Town Planner's Project Review
Wednesday, March 13, 2019

- X. **149 Mill Road Lot Line Adjustment.** Lot line adjustment between 149 Mill Road, Map 14, Lot 7-5 owned by Scott (and Claire) Righini and vacant lot on Map 14, Lot 7-7 owned by Adam, Jade, and Troy Fogg. Adam Fogg, Atlantic Survey, surveyor.
- I recommend that the board accept the application as complete and schedule a public hearing for March 27.

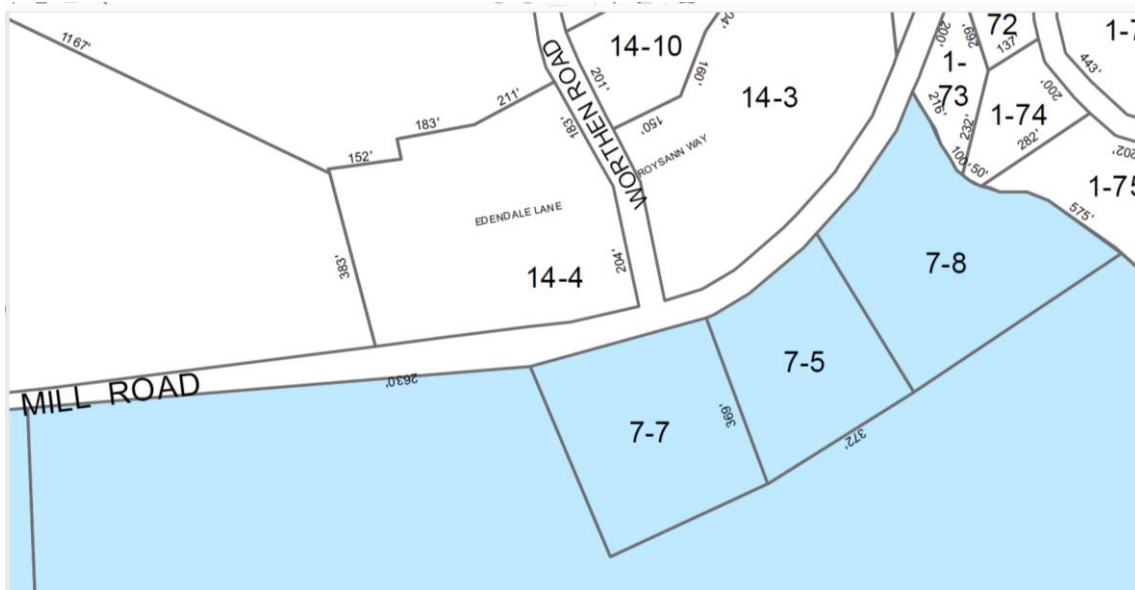
- 2) **Driveways.** There is a driveway on the easterly side of lot 7-5 serving the lot. There is a circular driveway situated mostly on lot 7-7 that serves lot 7-5. The purpose of the application is to place the circular driveway on lot 7-5. The question arises why there are two driveways serving lot 7-5. Here is some background information on the lot.
